AMENDMENT OF SOLICITATION/MODIFICATION OF CONTRACT

1. CONTRACT ID CODE	PAGE OF PAGES 1 | 135		
2. AMENDMENT/MODIFICATION NO. 0002	3. EFFECTIVE DATE 30-Jul-2007	4. REQUISITION/PURCHASE REQ. NO.	5. PROJECT NO.(If applicable)
6. ISSUED BY CODE W917PM AFGHANISTAN ENGINEER DISTRICT US ARMY CORPS OF ENGINEERS KABUL APO AE 09356		7. ADMINISTERED BY (If other than item 6) CODE **See Item 6**

ANA Bridgade at Kunduz
Changes to specifications:
1. Delete Section 00010 and replace with Revised Section 00010 Proposal Schedule
2. Delete Section 01010 and replace with Revised Section 01010 Scope of Work
3. Delete Section 01015 and replace with Revised Section 01015 Technical Requirements
4. Delete Section 01060 and replace with Revised Section 01060 Special Clauses.
5. Added Questions & Answers.
6. Added Sample Schedule.
7. Added Map for Kunduz 1150mx1150m site perimeter.
8. Added Appendix E Plans for the Wood Burning Stove Kitchen Annex: a) Appendix E Wood Stove Plan (E3). b) Appendix E Wood Stove Section (E5). c) Appendix E Wood Stove Section (E6). d) Appendix E Cross Section Layout
ALL OTHER TERMS AND CONDITIONS REMAIN UNCHANGED

Appendix B – Topographic Map

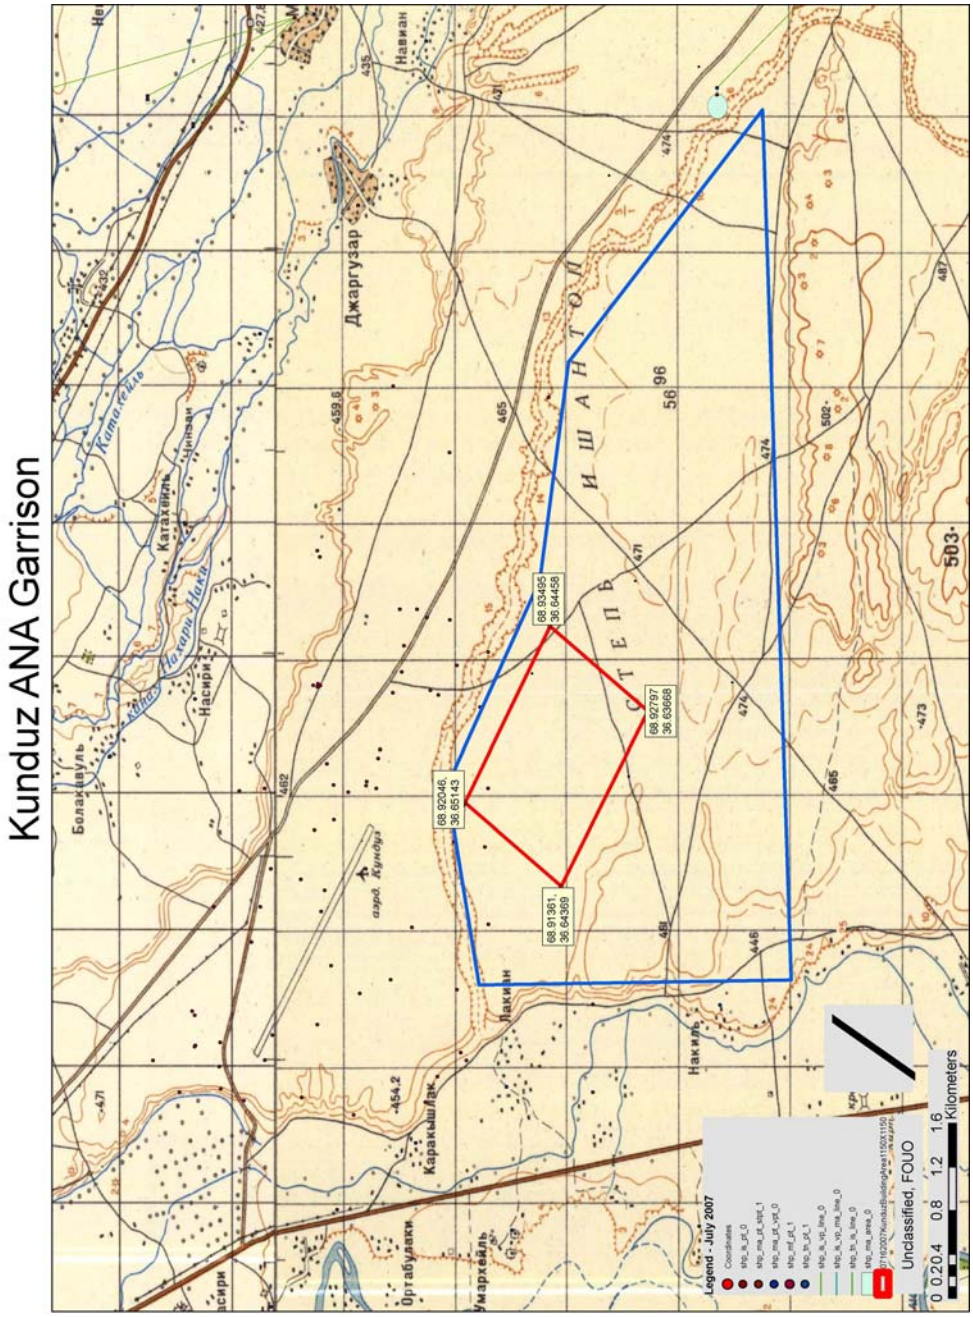
Question 30:
Please provide a reference point for the 1150m X1150m site within the coordinates provided in the RFP for Kunduz.

Answer: Map for Kunduz 1150mx1150m site perimeter is included.

Appendix E Wood Stove Plan (E3)
Appendix E Wood Stove Section (E5)
Appendix E Wood Stove Section (E6)
Appendix E Cross Section Layout

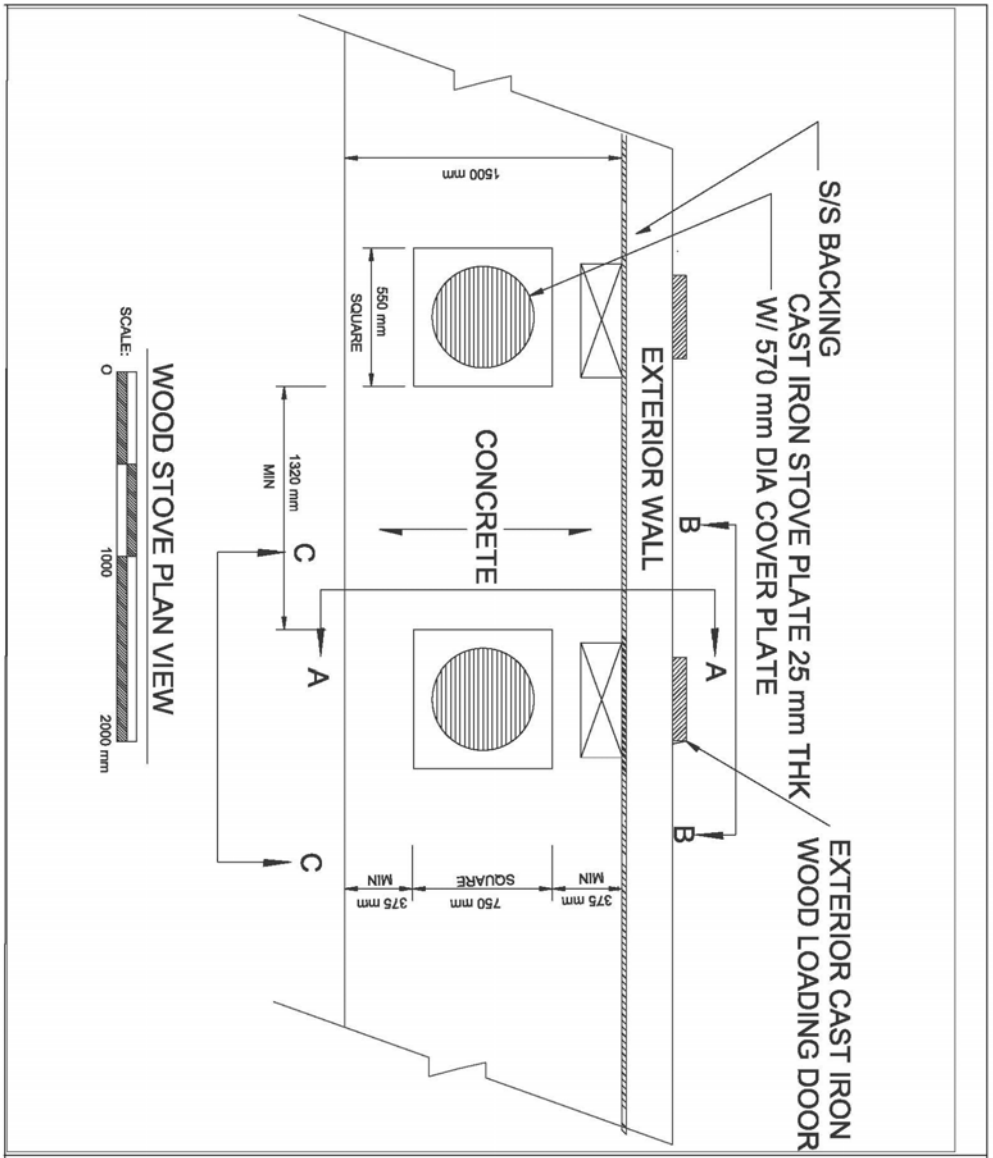
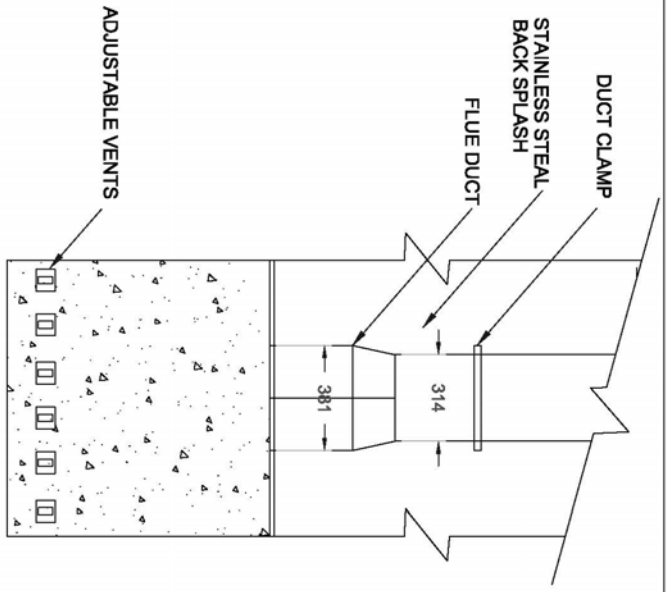
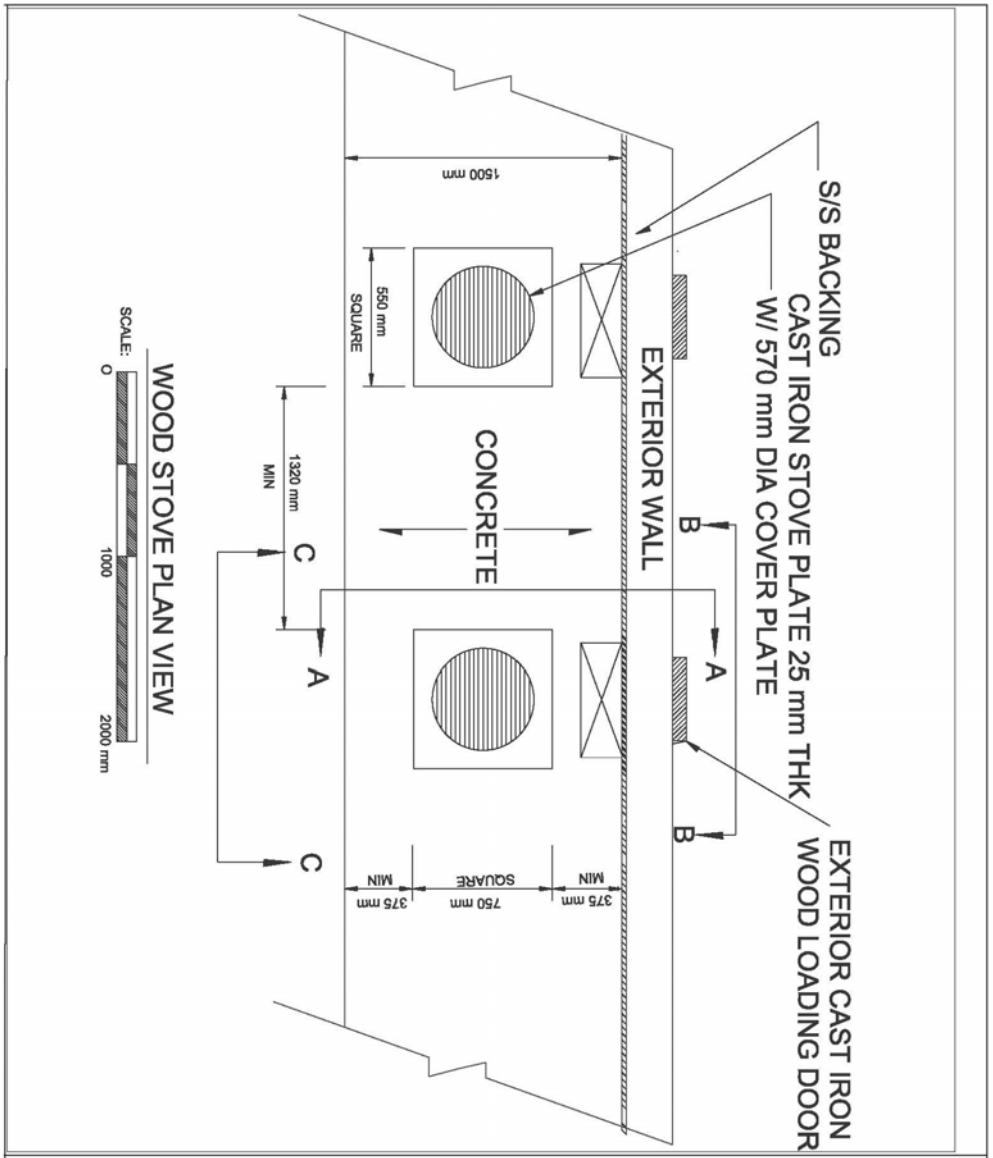
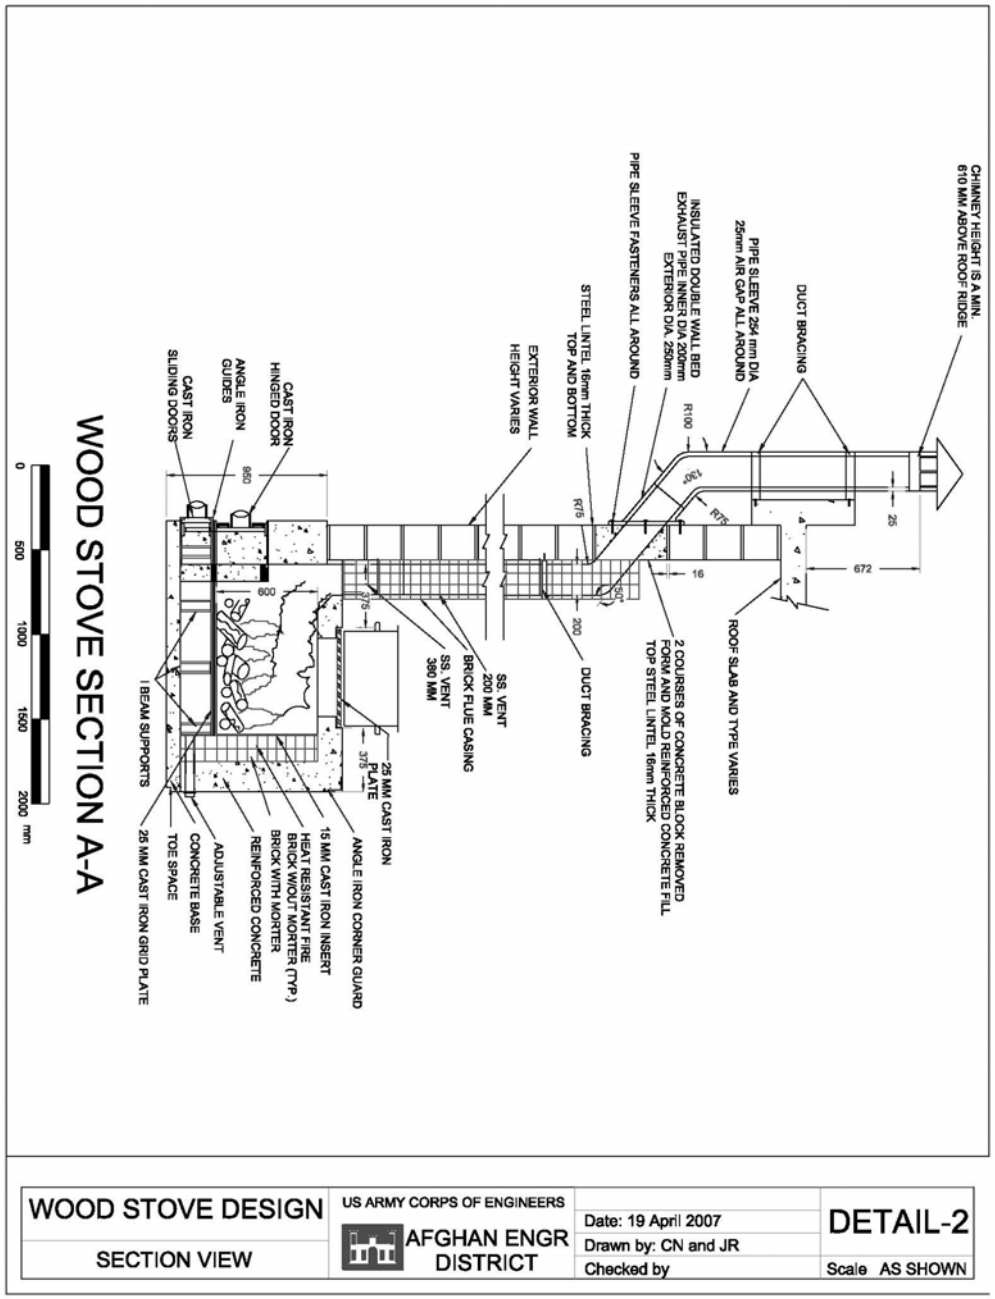
5. Added Questions & Answers.
6. Added Sample Schedule.
7. Added Map for Kunduz 1150mx1150m site perimeter.
8. Added Appendix E Plans for the Wood Burning Stove Kitchen Annex
Appendix E Wood Stove Plan (E3)
Appendix E Wood Stove Section (E5)
Appendix E Wood Stove Section (E6)
Appendix E Cross Section Layout
